GOVERNMENT PROCUREMENT POLICY BOARD

BIDS AND AWARDS COMMITTEE

Project: Supply, Delivery, and Installation of GPPB-TSO Local Area Network (LAN) Project

Bid Bulletin No.: 02

REVISED NETWORKCABLING RISER DIAGRAM

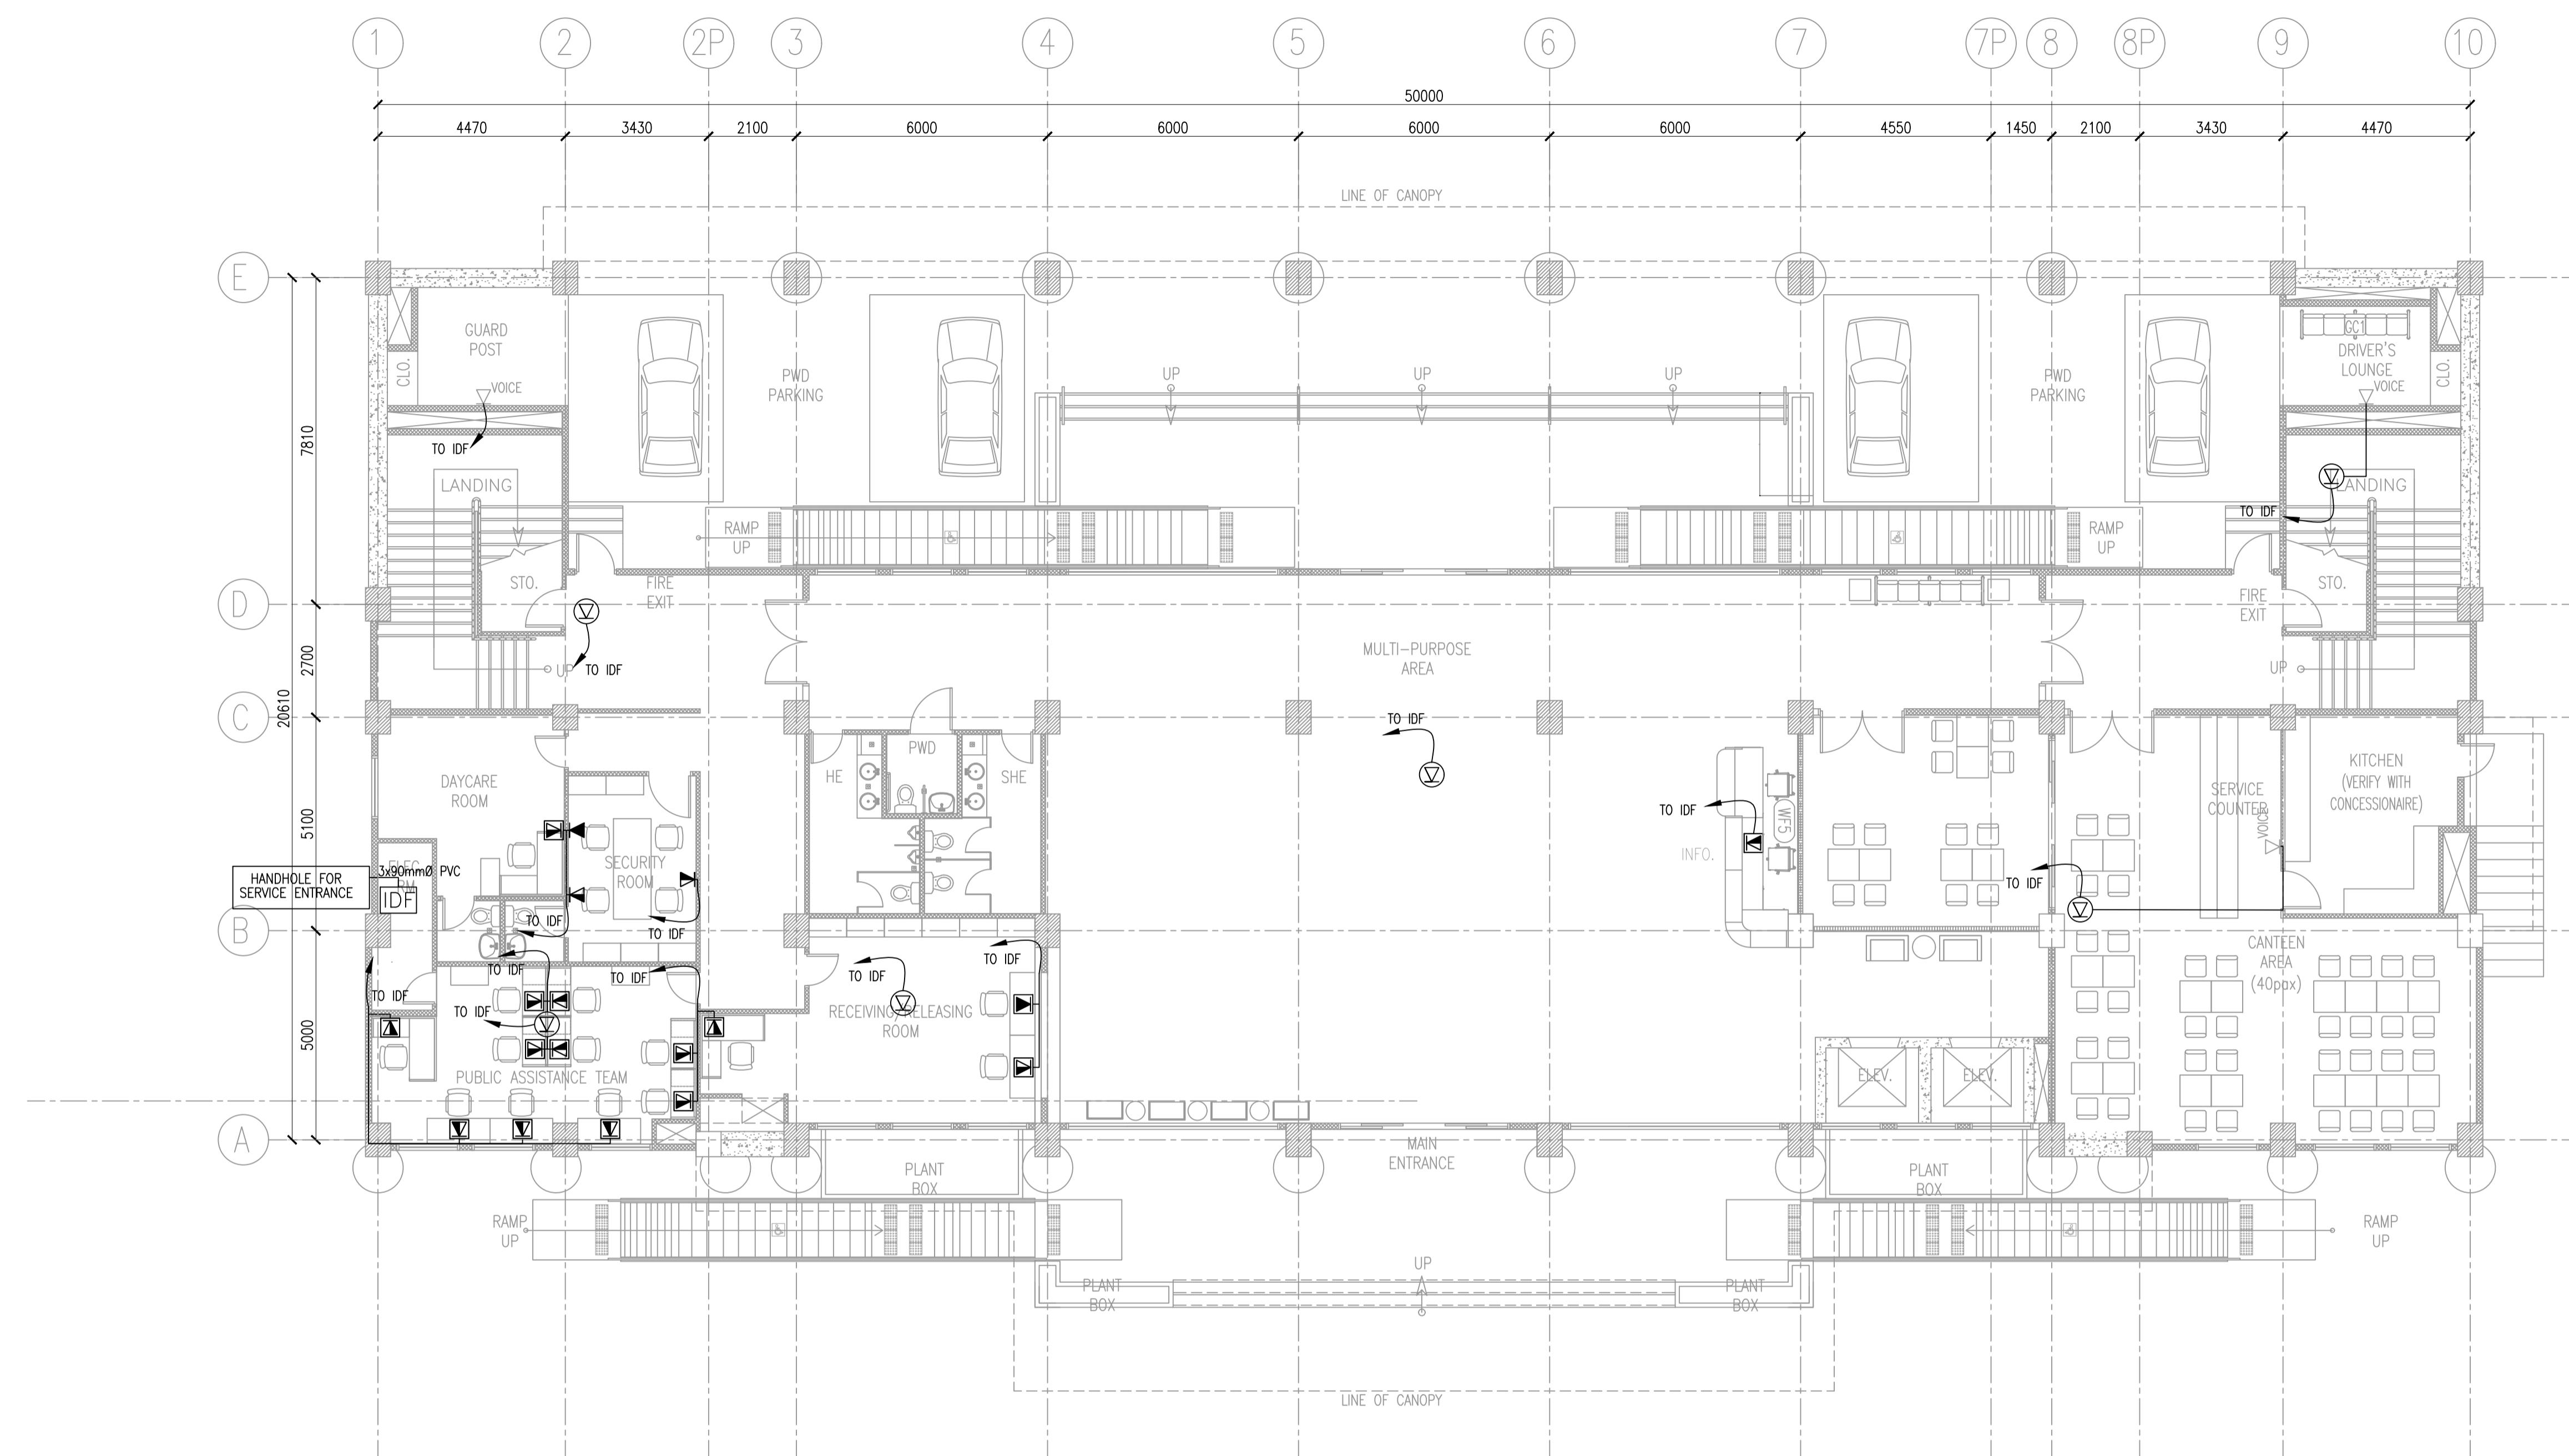
7. Is Network Cabling included in the Scope of Work?	No. Please refer to the Terms of Reference.
8. Can we request for an updated floor plan and a Horizontal and Vertical floor layout from the server room?	Refer to the attached revised floor plan, electrical and electronics plan for your reference.

NOTE	DESCRIPTION
<input checked="" type="checkbox"/>	HIGHLIGHTED OUTLETS ARE UNDER REVISE PLANS
<input type="checkbox"/>	NOT HIGHLIGHTED OUTLETS ARE UNDER ORIGINAL PLANS
